CBC Planning Reference –	SMD/2022/0088		
Site Name –	Advanced Proteins (AP), Cheddleton		
Summary of proposals -	Major factory building and associated office suite		
Consultation Note Subject –	Landscape and Visual Matters		
Planning Case Officer –	Jane Curley		
Landscape Comments Prepared By –	Stuart Ryder of Ryder Landscape Consultants		
Date of site visit —	18/5/22	Date of response	25/5/22
Recommendation –	Approve subject to landscape conditions

AP Protein Factory Extension Proposals, Cheddleton – Landscape and Visual Consultation

Extract from Staffordshire County Council's Online PRow Map – extracted 25/5/22

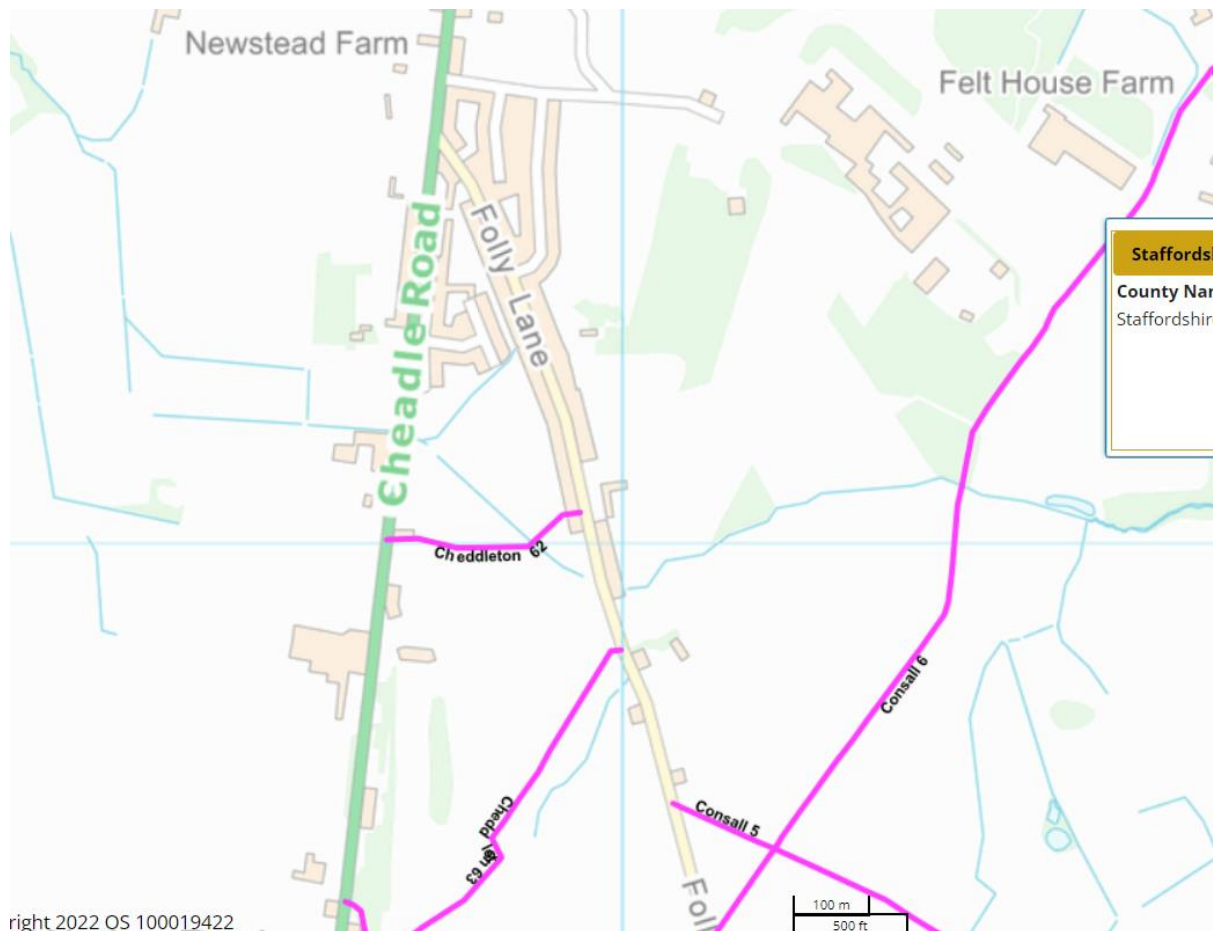
The two paths walked were Consall 5 and Consall 6. From these routes the existing factory could be discerned primarily because of the stacks that stand above it. The open ground of the Site could also be discerned in part which confirms there would be sight back to the proposed factory unit, it was difficult to define whether the office block would be visible.

The main unit would be visible in part until the establishment of the mitigation planting to the southern boundary. It would be a change to mid-distance views from these paths and cannot be classed as a beneficial change. However it is not necessarily and incongruous change given the existing factory back drop to the site.
